Phase out of DGPI and DGPIIL

SPC11系统中替换气缸DGPI/L

SPC200系统中替换气缸DGPI/L

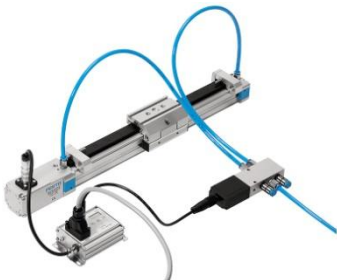
更换缸的同时，必须更换相应的传感器信号模块AIF，如下

DGPI-D2		peplaced by	DDLI
Ø	Part-No.		Part-No.
25	175134		1315779
32	175135		1344778
40	175136		1463452
50	175137		-
63	175138		1572299

DGPIL-D2		peplaced by	DGCI
Ø	Part-No.		Part-No.
25	175134		544426
32	175135		544427
40	175136		544428
50	175137		-
63	175138		544429

Existing with DGPI/L	
Type	Part-no.
SPC11-MTS-AIF	192218

New with DDLI/DGCI	
Type	Part-no.
SPC11-MTS-AIF-2	548128

注：如果需要更换控制器，需要把SPC11换成CMPX

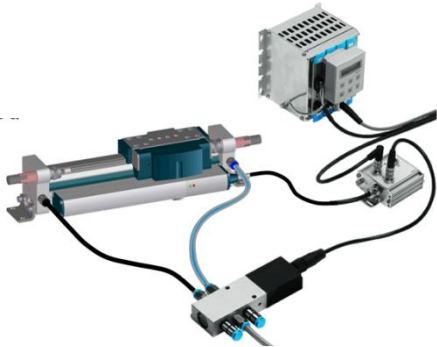
更换缸的同时，必须更换相应的传感器信号模块AIF，如下

DGPI-D2		peplaced by	DDLI
Ø	Part-No.		Part-No.
25	175134		1315779
32	175135		1344778
40	175136		1463452
50	175137		-
63	175138		1572299

DGPIL-D2		peplaced by	DGCI
Ø	Part-No.		Part-No.
25	175134		544426
32	175135		544427
40	175136		544428
50	175137		-
63	175138		544429

Existing with DGPI/L	
Type	Part-no.
SPC-AIF-MTS	170231

New with DDLI/DGCI	
Type	Part-no.
SPC-AIF-MTS-2	548128

注：如果需要更换控制器，需要把SPC200换成CMAX

DGPI dimensions

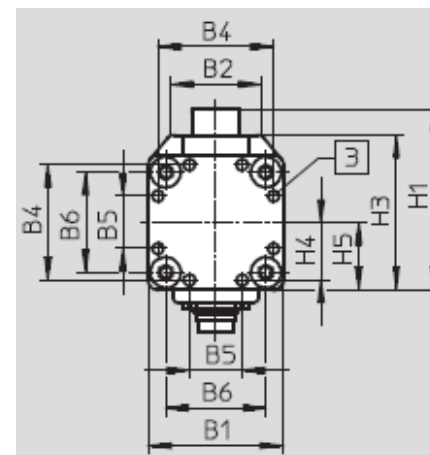
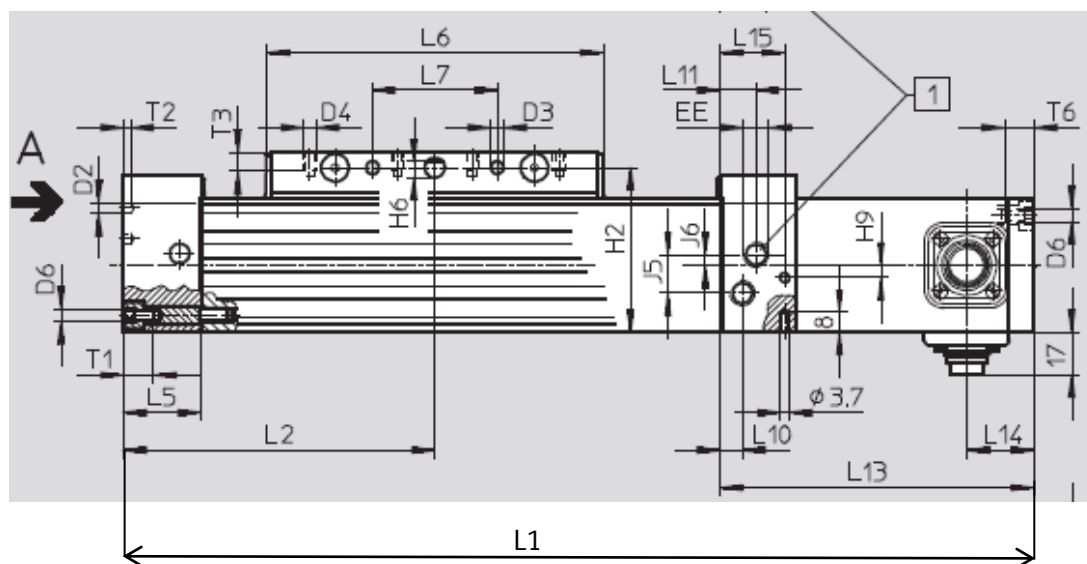
Ø 25	Ø 32	Ø 40	Ø 63
Length L 1 + stroke	301+	345+	397+	513+
Width B1	54	54	64	106

DDLI dimensions

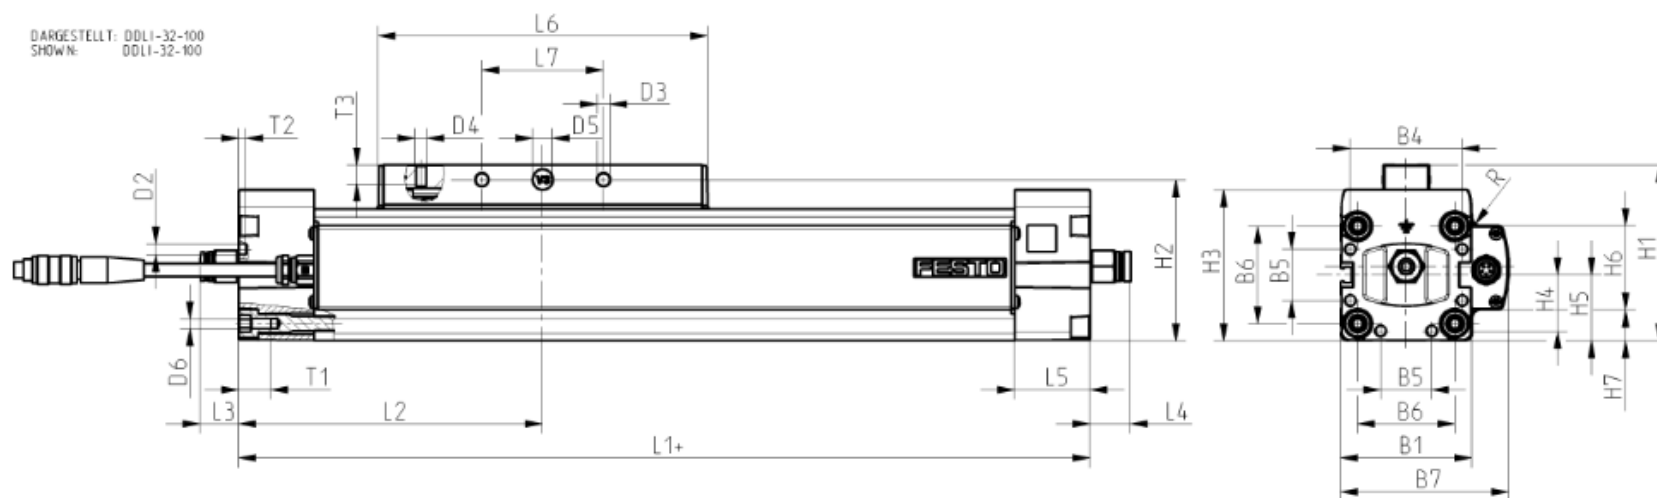
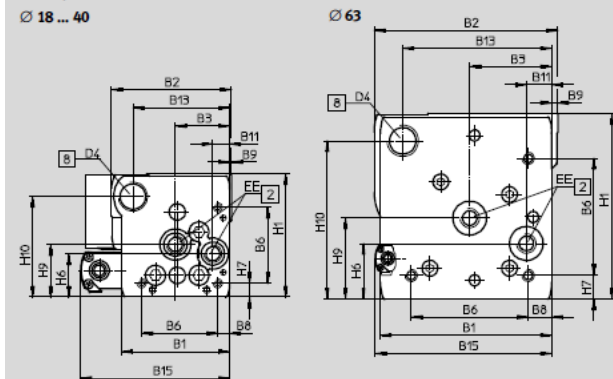
Ø 25	Ø 32	Ø 40	Ø 63
Length L 1+ stroke	200	250	300	400
Width B7	60,2	69,1	78,4	110,9
